Oroville Facilities Relicensing Environmental Study Reports Comments and Errata

OROVILLE FACILITIES RELICENSING ENVIRONMENTAL STUDY REPORTS COMMENTS AND ERRATA

Oroville Facilities Relicensing FERC Project No. 2100

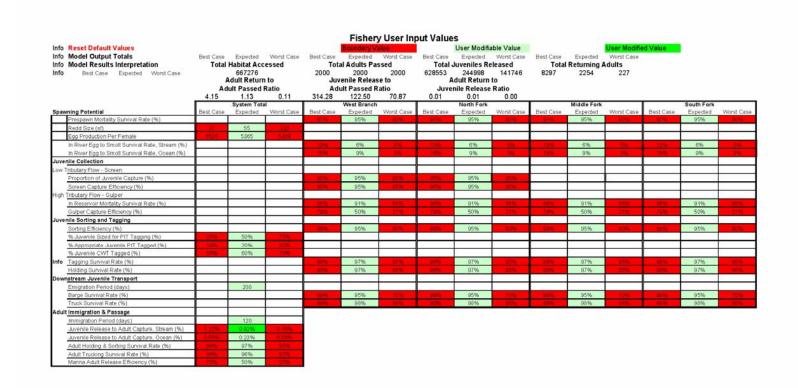
Much of the results are centered upon the outcome of one variable in the model, however we assert that "the performance target of a 1:1 adult passed to adult return ratio" (Task 3, p. 6-37) was not collaboratively selected and should not be focused on. Regardless, if just one variable is changed only slightly, the ratio becomes greater than 1:1 (Table 1).

The text should clearly describe the effect of a slight change in the "Juvenile Release to Adult Capture, Stream (%)" variables, and other variables as needed.
